Project	IEEE 802.16 Broadband Wireless Access Working Group < http://ieee802.org/16 >	
Title	MS Periodic Ranging in Non-transparent RS System under Distributed Scheduling	
Date	2006-03-05	
Submitted		
Source(s)	<p>Kanchei (Ken) Loa, Yi-Hsueh Tsai, Chih-Chiang Hsieh, Yung-Ting Lee, Hua-Chiang Yin, Shiann-Tsong Sheu, Frank C.D. Tsai, Youn-Tai Lee, Heng-Iang Hsu Institute for Information Industry 8F., No. 218, Sec. 2, Dunhua S. Rd., Taipei City, Taiwan.</p> <p>Hang Zhang, Peiyong Zhu, Mo-Han Fong, Wen Tong, David Steer, Gamini Senarath, Derek Yu, Mark Naden, G.Q. Wang Nortel 3500 Carling Avenue Ottawa, Ontario K2H 8E9</p> <p>[add co-authors here]</p>	<p>Voice: +886-2-2739-9616 loa@iii.org.tw</p> <p>Voice: +1 613 7631315 WenTong@nortel.com pyzhu@nortel.com</p>
Re:	IEEE 802.16j-07/007r2: "Call for Technical Comments and Contributions regarding IEEE Project 802.16j"	
Abstract	This contribution proposes procedures for MS periodic ranging in non-transparent RS

MS Periodic Ranging in Non-transparent RS System under Distributed Scheduling

Table yyy: Ranging and automatic adjustment procedure in non-transparent RS systems under distributed scheduling

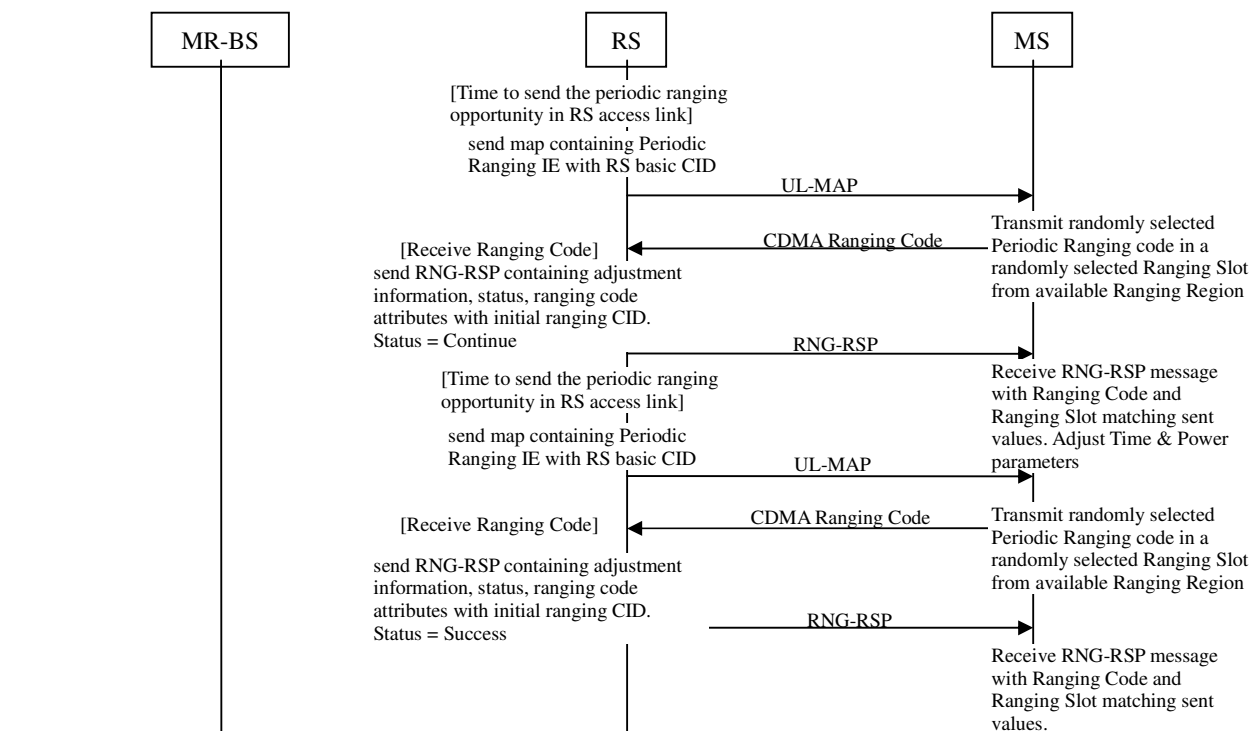
When RS receives the CDMA ranging code, RS shall locally send RNG-RSP to MS on the access link.

The message sequence charts (Table 364 and Table yyy) and flow charts (Figure zzz) define the periodic ranging and adjustment process that shall be followed by compliant RSs and MR-BSs.
